Environmental Audit Of the Greens Creek Mine

FINAL REPORT

SRK Project 1UK005.001

March 2009

Figure 3: Production Rock Classification System – Comparison of NNP and NP/AP Criteria

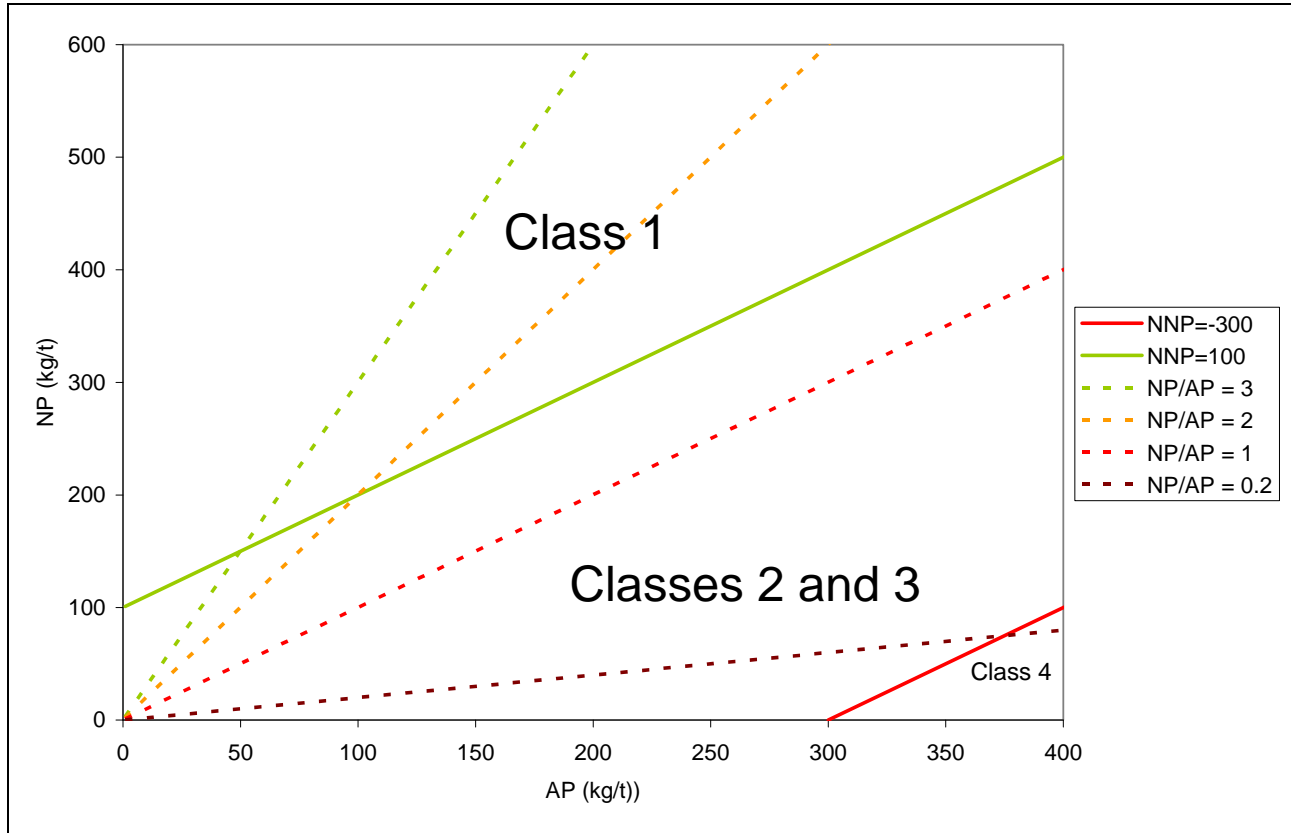
- The geochemical classification system – the NNP-based approach is out-of-date compared to current NP/AP-based approaches (Figure 3). In fact, the original basis for the classification system does not appear to be well established. Class 1 overlaps into NP/APs between 1 and 2, which are usually considered to represent classification uncertainty. However, since most Rock in Class 1 has AP<100 kg CaCO₃/t, this is not a significant concern. The system is based on ARD potential rather than metal leaching potential. However, modeling by HGCMC has considered leaching of zinc and cadmium from the production rock (see Section 4.2.2.6).
